SITE PLAN AMENDMENT - SPAA-001050-2019

SPECIAL REVIEW USE - SRU-001049-2019

SITE PLAN AMENDMENT NO.1

PUBLIC SERVICE COMPANY OF COLORADO
230 KV NEIGHBORHOOD ELECTRIC SUBSTATION
COVER SHEET
SITE PLAN AMENDMENT - SPAA-001050-2019
SPECIAL REVIEW USE - SRU-001049-2019

DRAWING TITLE:
OVERALL UTILITY PLAN

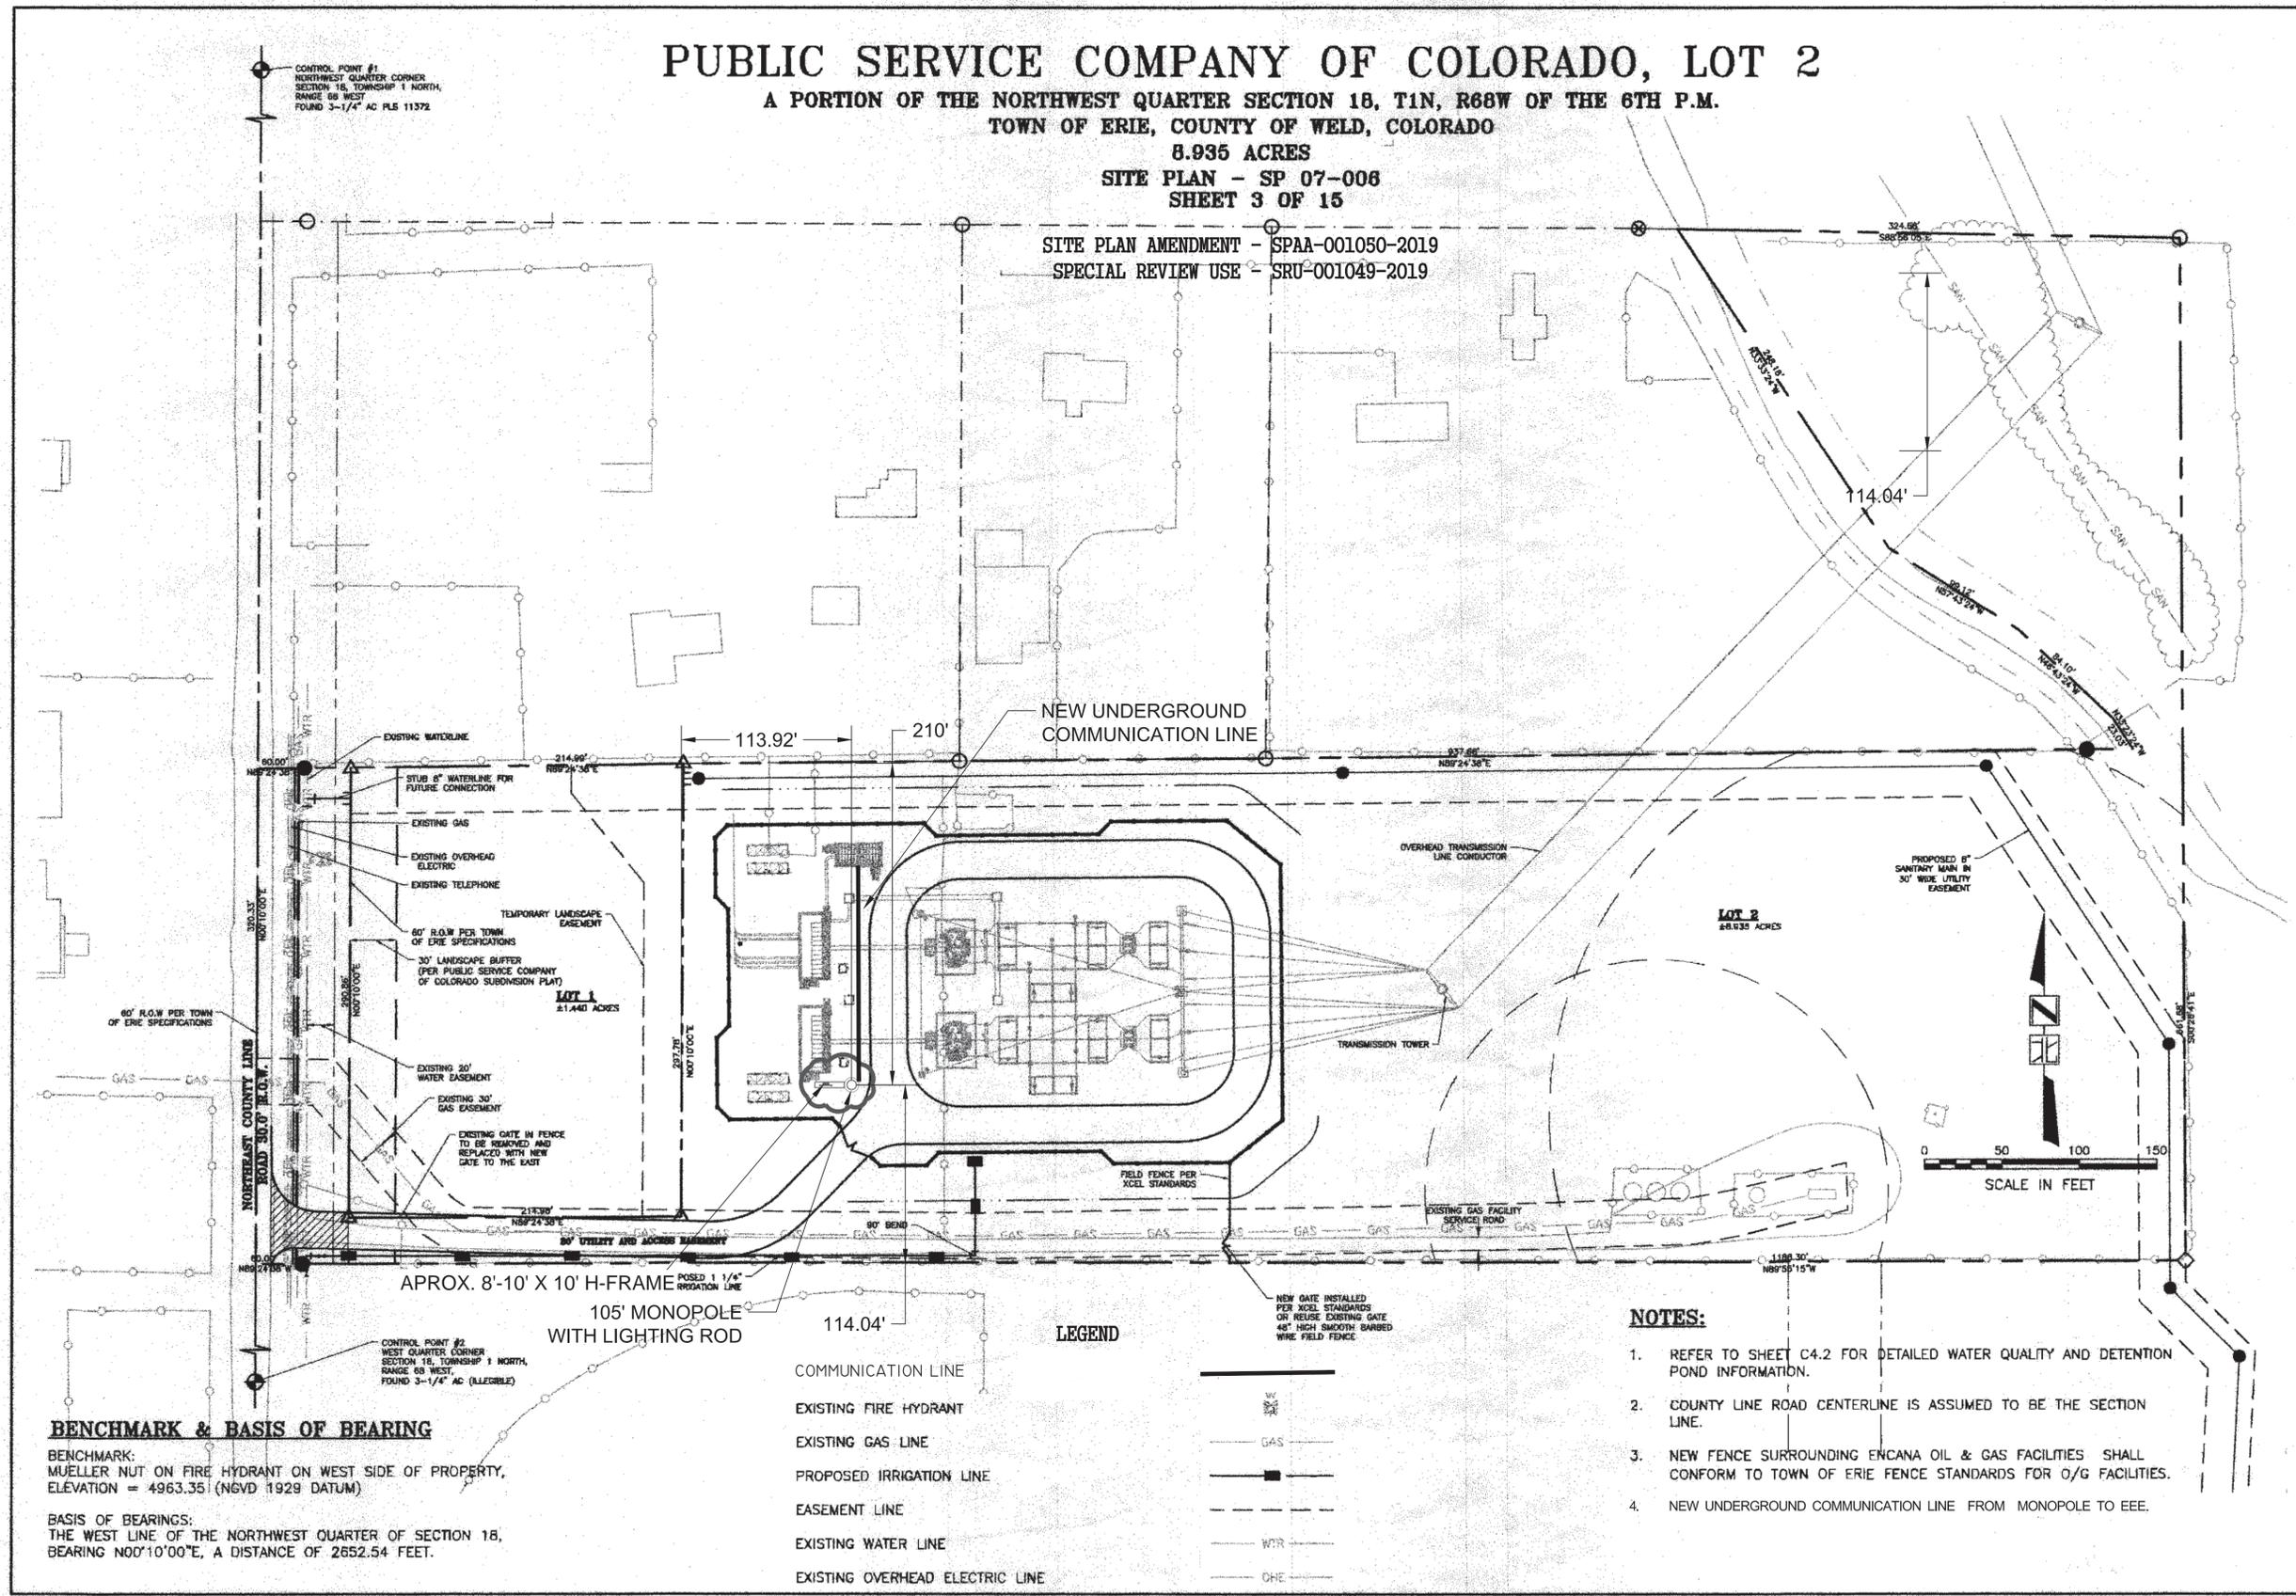
- NOTES:**
1. REFER TO SHEET C4.2 FOR DETAILED WATER QUALITY AND DETENTION POND INFORMATION.
 2. COUNTY LINE ROAD CENTERLINE IS ASSUMED TO BE THE SECTION LINE.
 3. NEW FENCE SURROUNDING ENCANVA OIL & GAS FACILITIES SHALL CONFORM TO TOWN OF ERIE FENCE STANDARDS FOR O/G FACILITIES.
 4. NEW UNDERGROUND COMMUNICATION LINE FROM MONOPOLE TO EEE.

DRAWING TITLE:
DRAINAGE PLAN

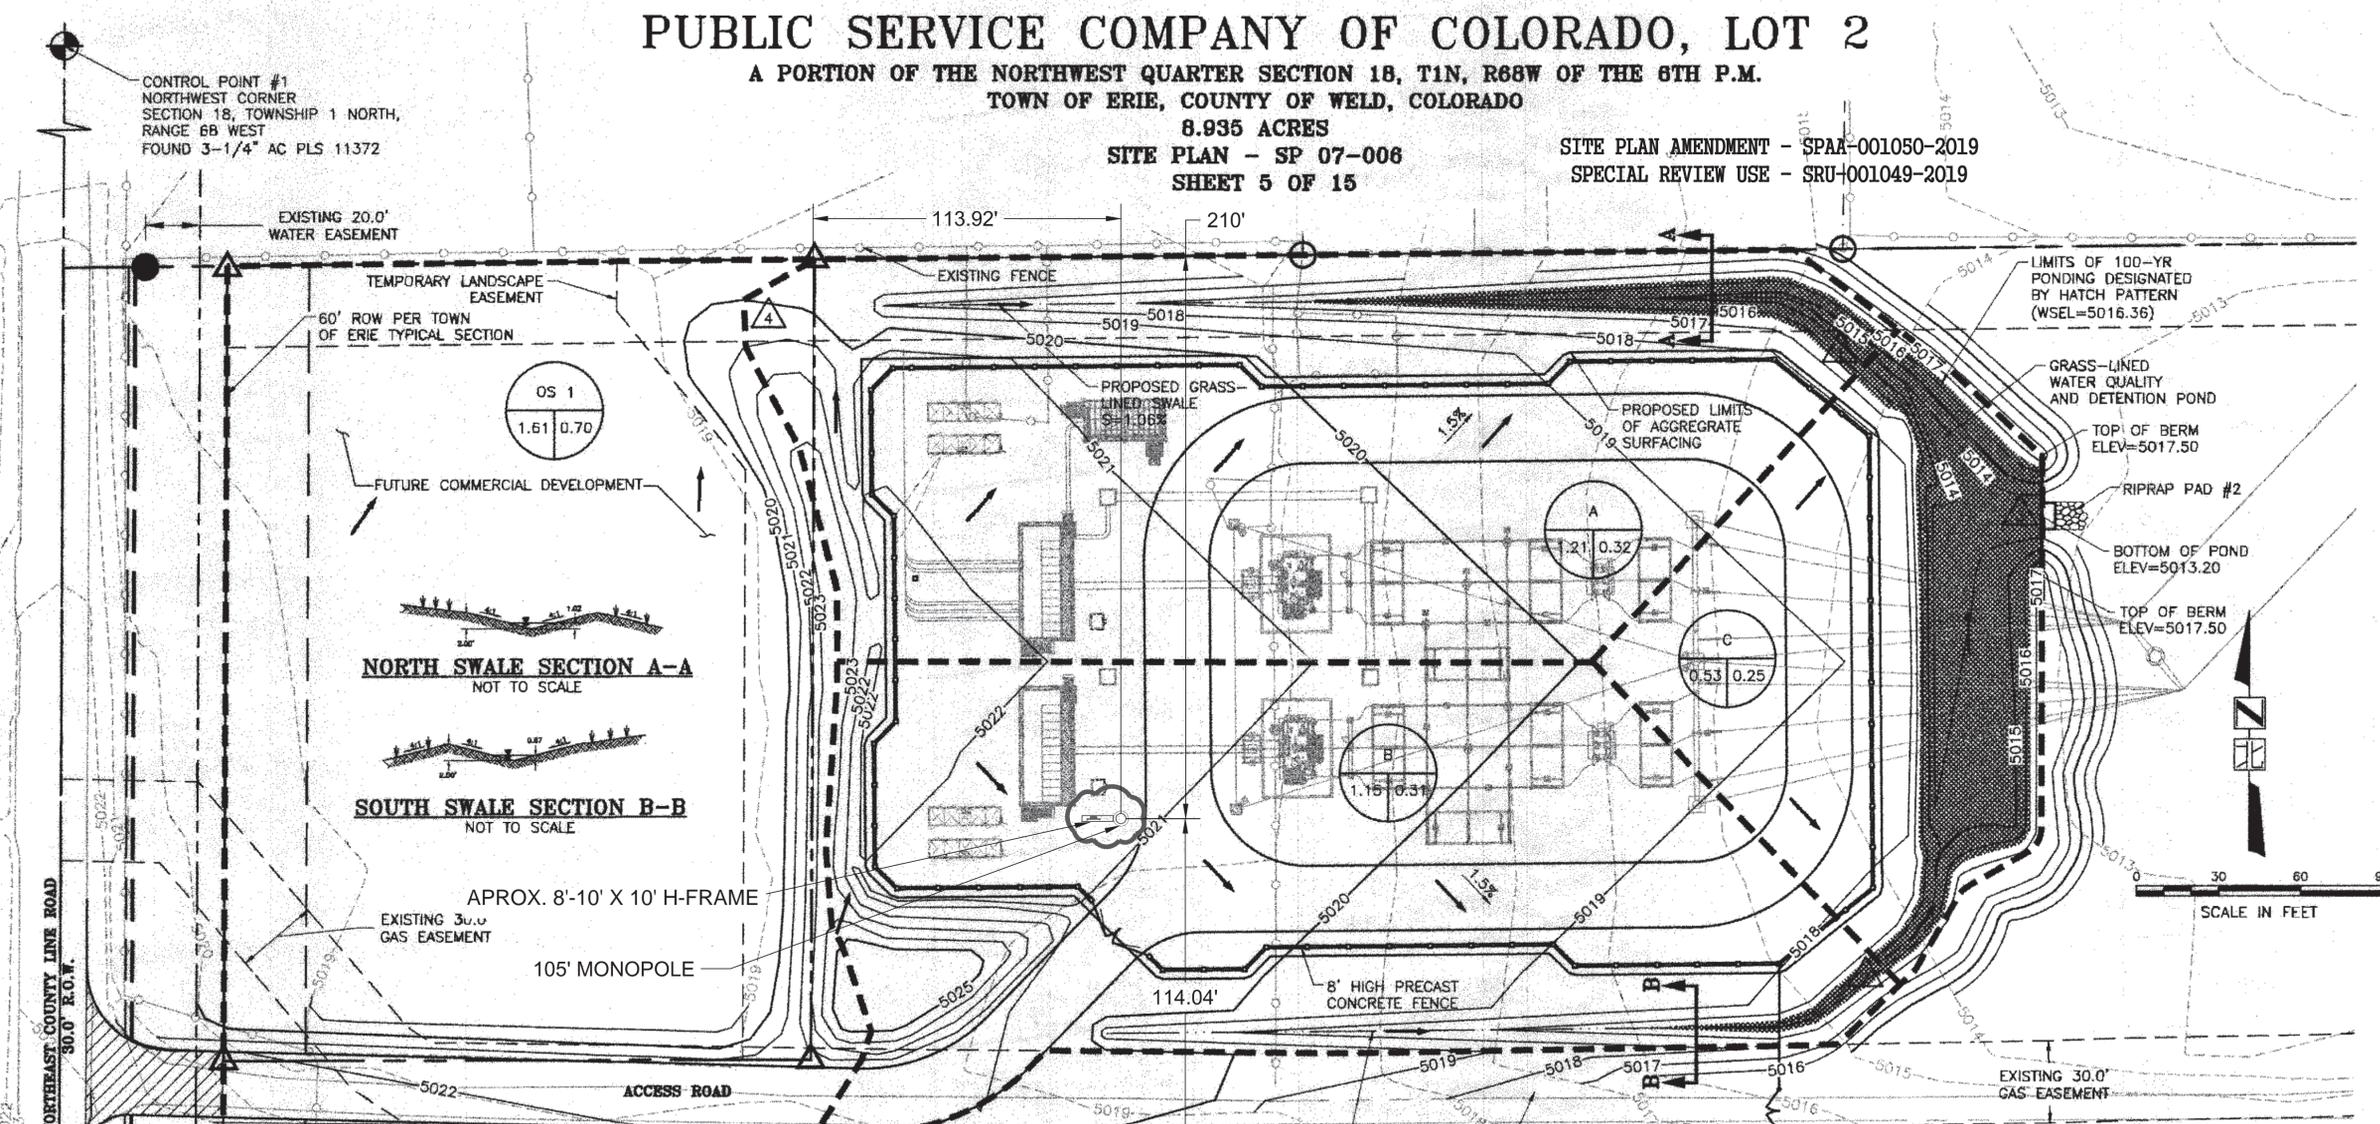
- NOTES:**
- THIS DRAWING SHOWN AT 1" TO 30' FOR CLARITY.
 - REVEGETATION IS SHOWN ON THE SITE MATERIALS PLAN, SHEET 7 OF 15.
 - THE GRADING AND DRAINAGE WILL BE UNCHANGED AS A RESULT OF THE FAN MONOPOLE. DURING CONSTRUCTION OF THE FAN MONOPOLE CREWS WILL EXCAVATE FOR THE FOUNDATION AND SPOIL PILE WILL BE WITHIN THE SUBSTATION. ANY REMAINING MATERIAL FROM SPOIL PILE WILL BE REMOVED AND HAULED TO A LANDFILL.

DRAWING TITLE:
**PHOTO-
 METRIC
 PLAN**

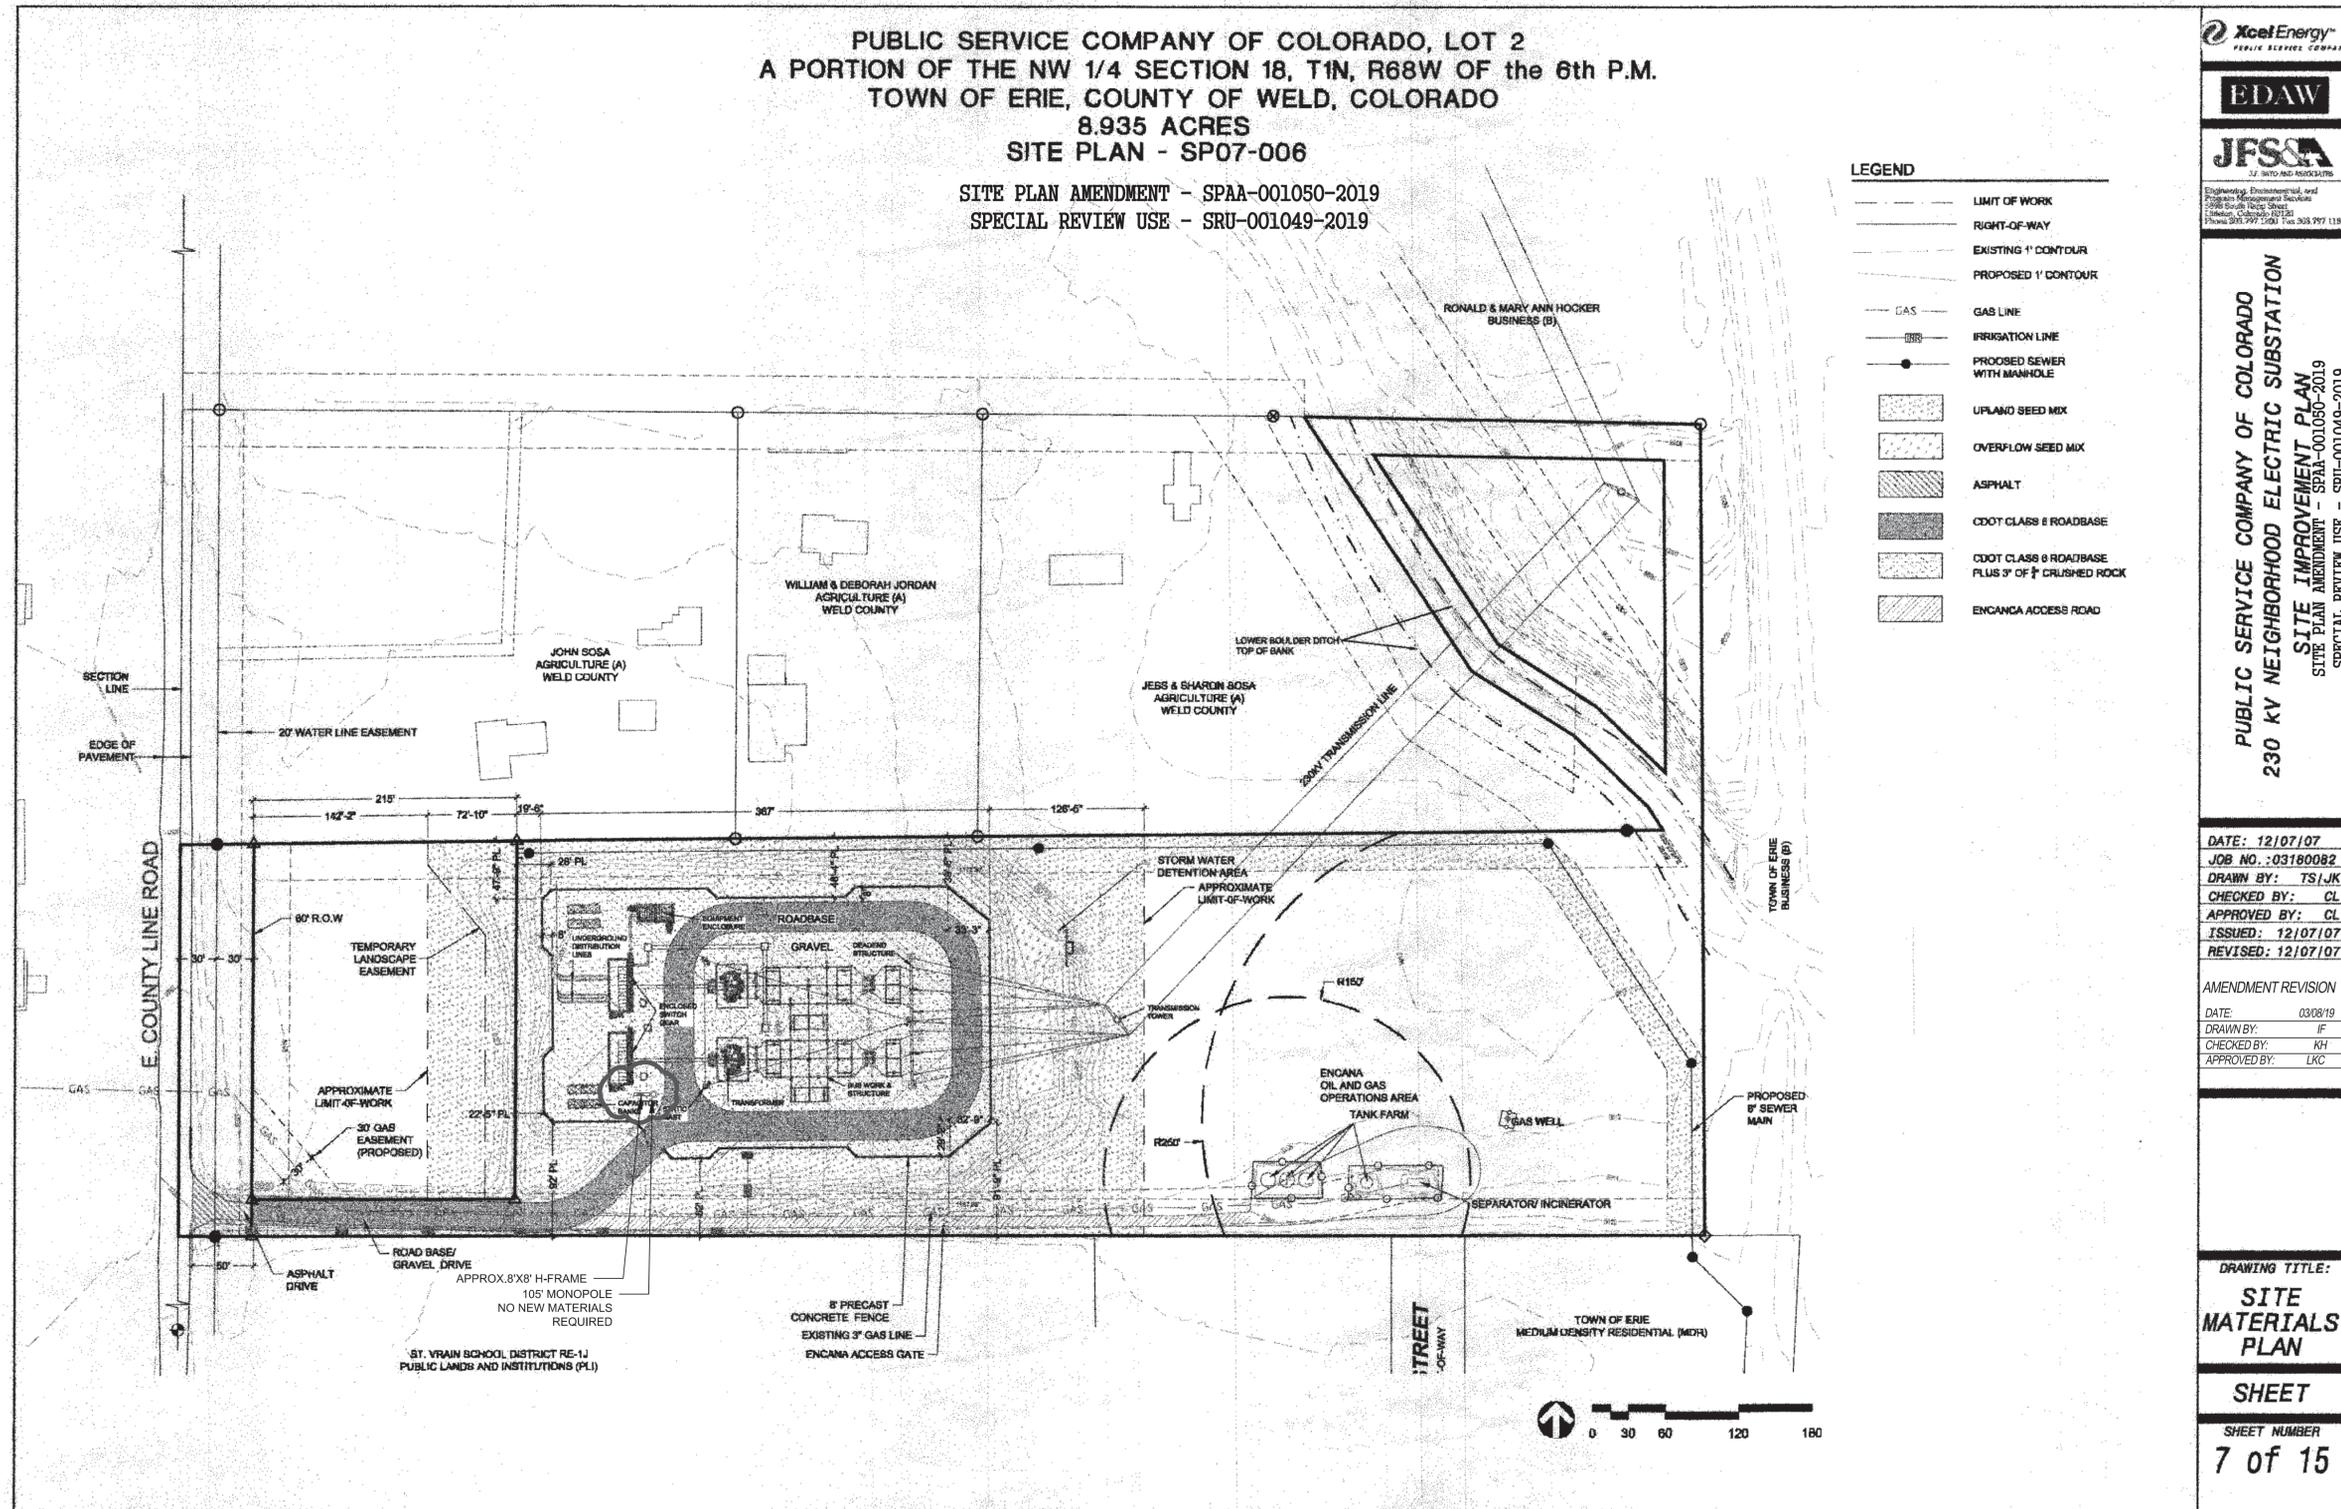
105' MONOPOLE
NO LIGHTING
REQUIRED
